RESOURCE CONSENT RMA/2022/3611 – AMENDMENT TO THE LAND USE AND SUBDIVISION APPLICATION 320 AND 320A CUMNOR TERRACE, CHRISTCHURCH

1. This letter sets out an amendment to the above resource consent application to address matters raised in Council's s95 report. It also provides comment on certain aspects of the report.

**PORTLINK INDUSTRIAL PARK
STAGE 6-8**

**DESIGN FINAL CONTOURS &
BUND PLAN**

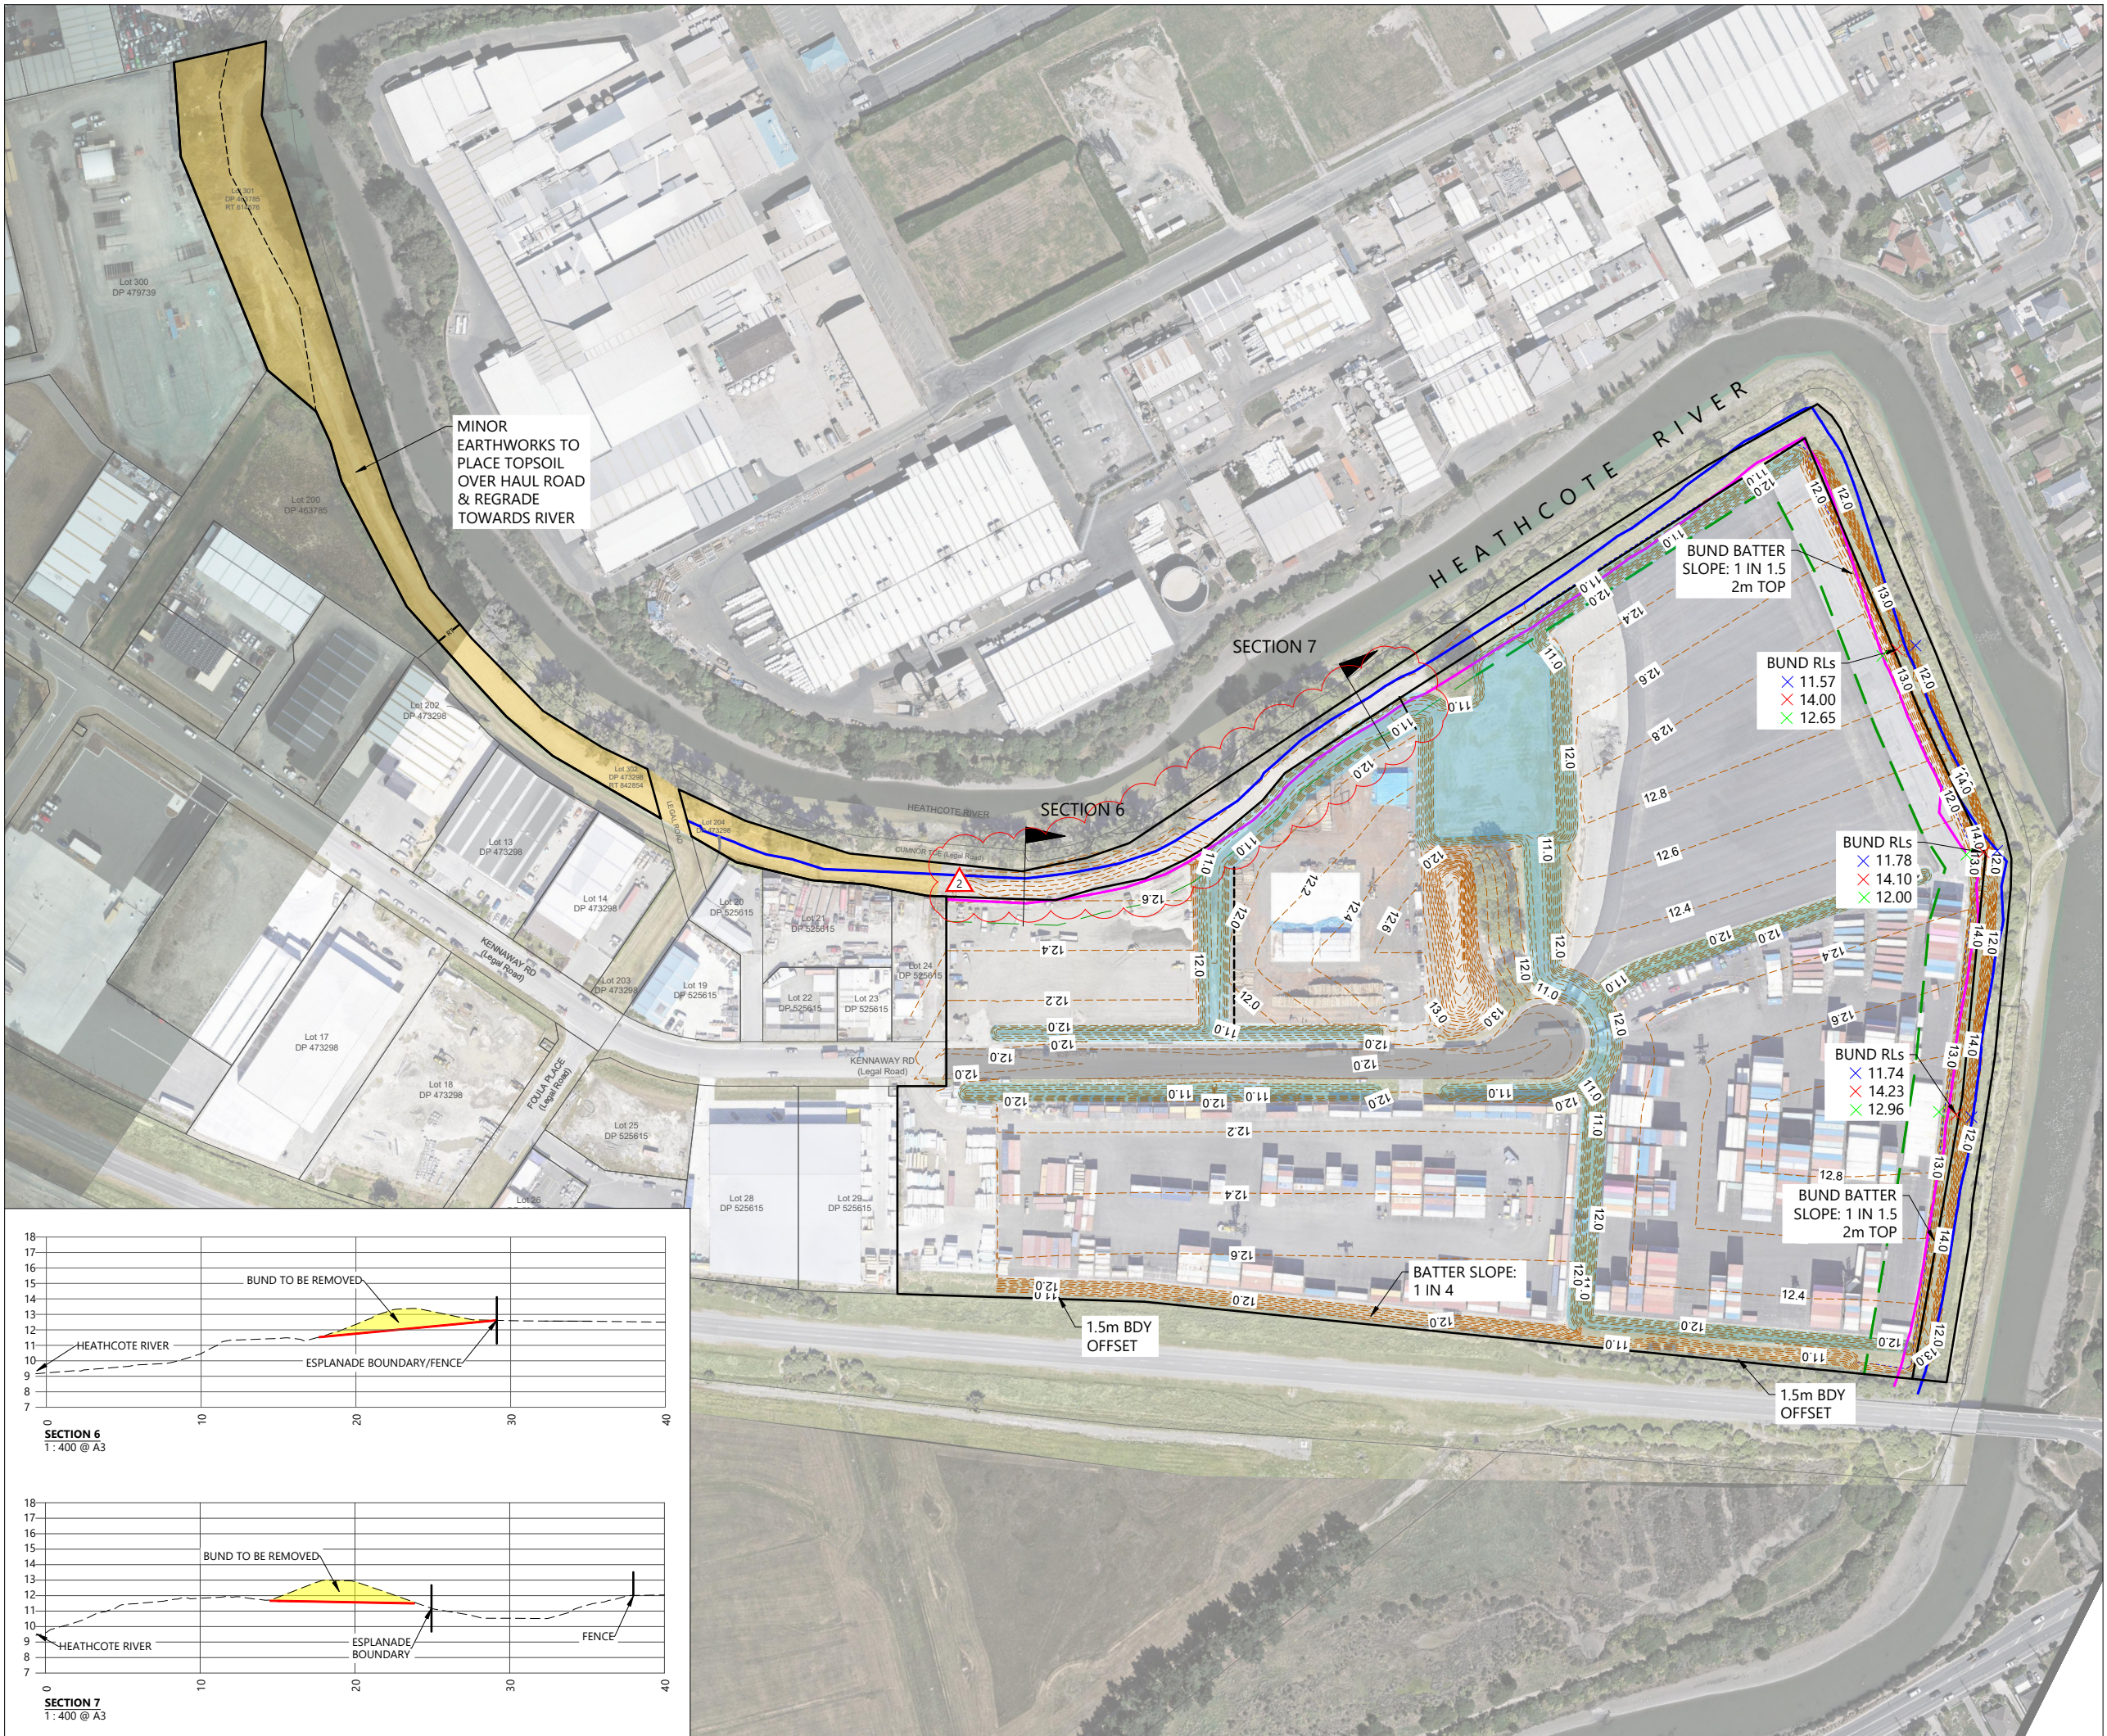
10. The s95 report assesses that the proposed southwest bund will have more than minor adverse effects due to impacts on ecology, ecological habitat, character and amenity. To address these concerns the application has been amended to remove the bund and instead provide a gentle batter slope extending towards the river from the level of the adjoining industrial yards. This amendment also allows for a re-aligned pathway to follow the eastern boundary of the proposed esplanade reserve consistent with the treatment elsewhere. The **attached** landscape plans and contour plan show the amended proposal.

REVISION DETAILS	BY	DATE
1 ISSUED FOR APPROVAL	RJH	21/11/2022
2 SOUTHWEST BUND REMOVED	AM	18/09/2023

B. BUND CROSS SECTION A-A (SCALE 1:100)

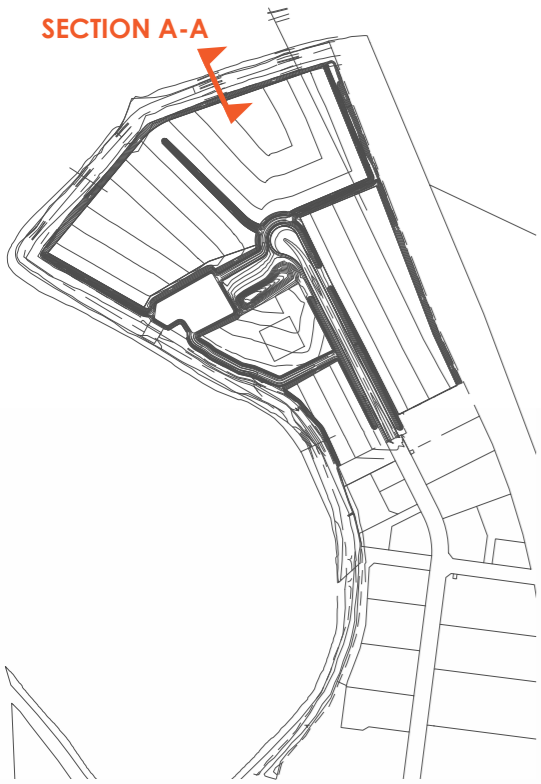
4. To reduce the adverse effects of the proposed activity, the applicant makes the following amendments to the application:
 - Removal of the proposal to allow buildings to exceed 11 metres in height within the 11-metre building height limit area indicated on the Portlink ODP.
 - Reduction in the height of any buildings and/or outdoor storage within the ODP Greenspace to 5.8 metres
 - Altering the proposed landscape treatment on the northern bund as follows:
 - o Relocating the proposed acoustic fence as far to the rear (south) of the bund crest as possible,

- Leaving the north face of the northern bund in its current state (i.e. rank grass coverage),
 - Reducing the vertical screening vegetation on the bund crest so that it is as far back from the north face of the bund as possible,

FACE OF BUND LEFT AS RANK GRASS FOR LIZARD HABITAT

PROPOSED 2.4m ACOUSTIC FENCE ON TOP OF EXISTING BUND

PROPOSED NATIVE PLANTING FOR SOFTENING AND SCREENING ON EXISTING BUND

Test Hole 1.

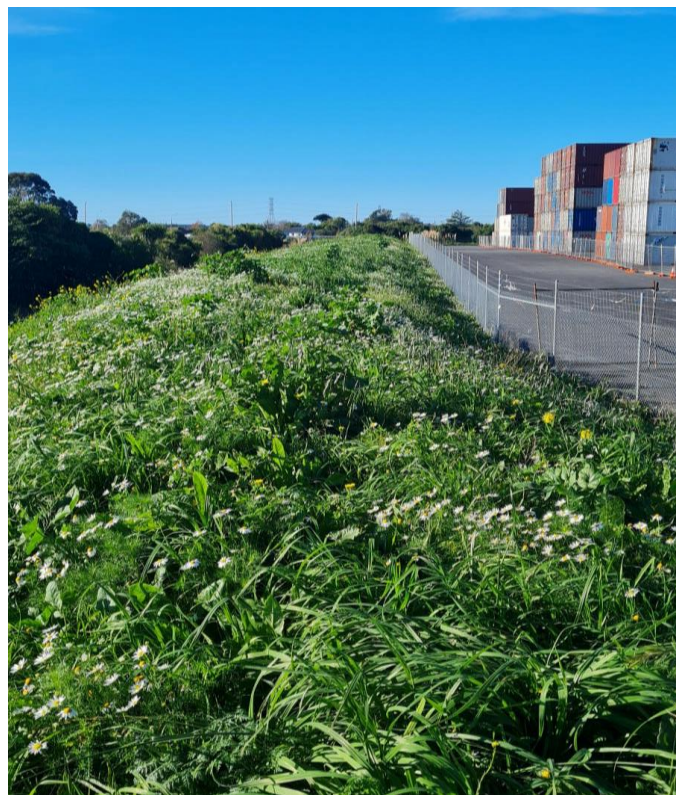
15. The applicant originally stated that the construction of the northern bund comprises a crushed concrete core covered by approximately 0.3 metres of topsoil. The s95 report, based on advice from Council's landscape architect, considers this depth is insufficient to support growth of tree species with a height at maturity of 8 metres.

16. The applicant's landscape contractor (Outer Space) investigated the bund and established the minimum depth of topsoil on the bund crest is between 0.85 - 1 metre (see **attached** documentation). Outer Space is confident this depth is sufficient to accommodate the growth (to maturity) of proposed species. The applicant would accept a condition of consent requiring further excavation and backfill with a 50/50 mix of organic compost and imported soil if insufficient soil depth is found during planting. This condition, alongside the proposed landscape maintenance period, will ensure the proposed species thrive and screen the acoustic fence and activities in the ODP Greenspace to the south of the bund within short period of time.

In summary, the soil depth on site is excellent and ranges between 850-1000mm. It is evident through the growth of the current vegetation that the soil is fertile and sufficient for growing the selected trees and shrubs. (see the picture below)

In the event that insufficient soil is found, then we recommend excavating a tree pit and backfilling with a 50/50 mix of organic compost and imported soil.
